DEPARTMENT OF TRANSPORTATION

Contract #: 04-0120F4Cty: SF/ALA Rte: 80 PM: 13.2/13.9File #: 69.28**WELDING INSPECTION REPORT****Resident Engineer:** Pursell, Gary**Address:** 333 Burma Road**City:** Oakland, CA 94607**Report No:** WIR-002552**Date Inspected:** 15-May-2008**Project Name:** SAS Superstructure**OSM Arrival Time:** 1330**Prime Contractor:** American Bridge/Fluor Enterprises, a JV**OSM Departure Time:** 2230**Contractor:** Zhenhua Port Machinery Company, Ltd (ZPMC), Changxing Island **Location:** Shanghai, China

Orthotropic Box Girder (OBG) Fabrication

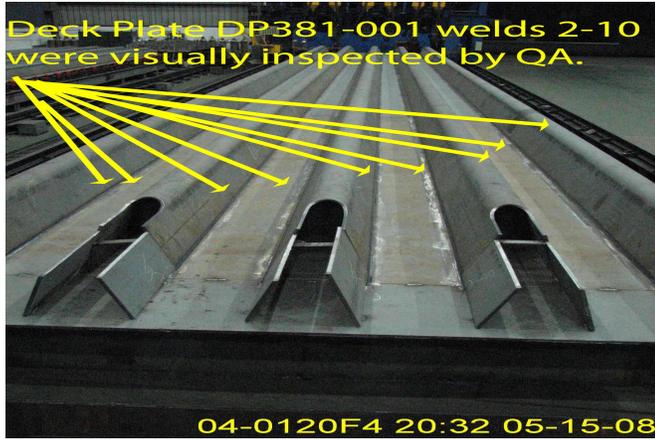
The QA Inspector performed random visual inspections of deck plate DP381-001 closed rib welds #2 through #10. The QA Inspector used a yellow marker to identify locations on these welds that have various degrees of weld insufficient fill, weld overlap, and other similar weld conditions. The results of these inspections were documented on forms titled: "Caltrans QA Visual Weld Inspection Report for the OBG Deck Panels". These completed forms were submitted to Caltrans engineering for review. See the photograph below showing typical weld defects in deck panel DP381-001.
